DART SERVICE INSTRUCTION

TO AMEND INSTALLATION INSTRUCTIONS D350-607-3 Rev.D,
INSTALLATION INSTRUCTIONS D350-607-4 Rev. C AND
INSTRUCTIONS FOR CONTINUED AIRWORTHINESS ICA-D350-607 REV. 6

REF TCCA STC: SH94-14
REF FAA STC: SR00213NY
REF EASA STC: EASA.10016996
REF BRAZILIAN STC: 2007S03-03/-04/-05/-06

A	NEW ISSUE	AJS	14.05.16
REV.	DESCRIPTION	BY	DATE
DESIGN	AJS	DART AEROSPACE LTD	
DRAWN	AJS	HAWKESBURY, ONTARIO, CANADA	
CHECKED	N/A	DRAWING NO.	REV. A
MFG. APPR.	N/A	DSI 9699	SHEET 1 OF 2
APPROVED		TITLE	SCALE
DE APPR.		LUG REPLACEMENT	NTS
DATE	14.05.16	COPYRIGHT © 2014 BY DART AEROSPACE LTD	
THIS DOCUMENT IS PRIVATE AND CONFIDENTIAL AND IS SUPPLIED ON THE EXPRESS CONDITION THAT IT IS NOT TO BE USED FOR ANY PURPOSE OR COPIED OR COMMUNICATED TO ANY OTHER PERSON WITHOUT WRITTEN PERMISSION FROM DART AEROSPACE LTD

FIGURE 1: INSTALLATION OF D4775-041 FWD STRUT

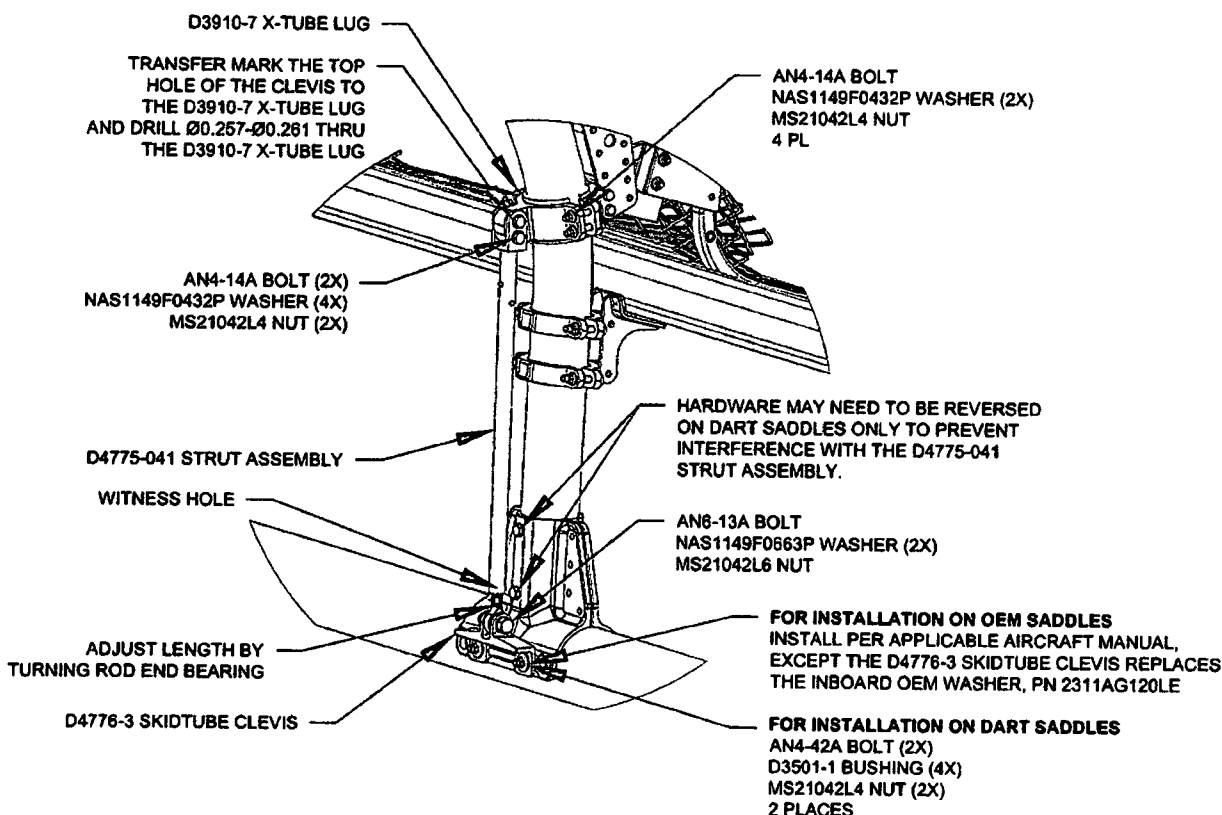
- 3.1 Substitute the Forward Lower D3910-5 X-Tube Lug with the D3910-7 X-Tube Lug as shown in Figure 1.
- 3.2 Install the forward D4775-041 Strut Assembly. Transfer mark from the upper hole on the clevis of the D4775-041 Strut Assembly to the D3910-7 X-tube Lug and drill thru the lug $\varnothing 0.257$ - $\varnothing 0.261$ as shown in Figure 1. Touch up chemical conversion coating per MIL-DTL-5541. Check the witness holes located at the bottom end of the D4775-041 Strut Assemblies to ensure that the thread from the rod end extends past the witness hole.
Torque MS21042L4/-4 nuts to 50-70 in-lbs (5.7-7.9 N-m). Torque MS21042L6/-6 nuts to 160-190 in-lbs (18.1-21.5 N-m).
- 3.3 Complete the installation in accordance with Installation Instructions D350-607-3 Rev. D or D350-607-4 Rev. C.
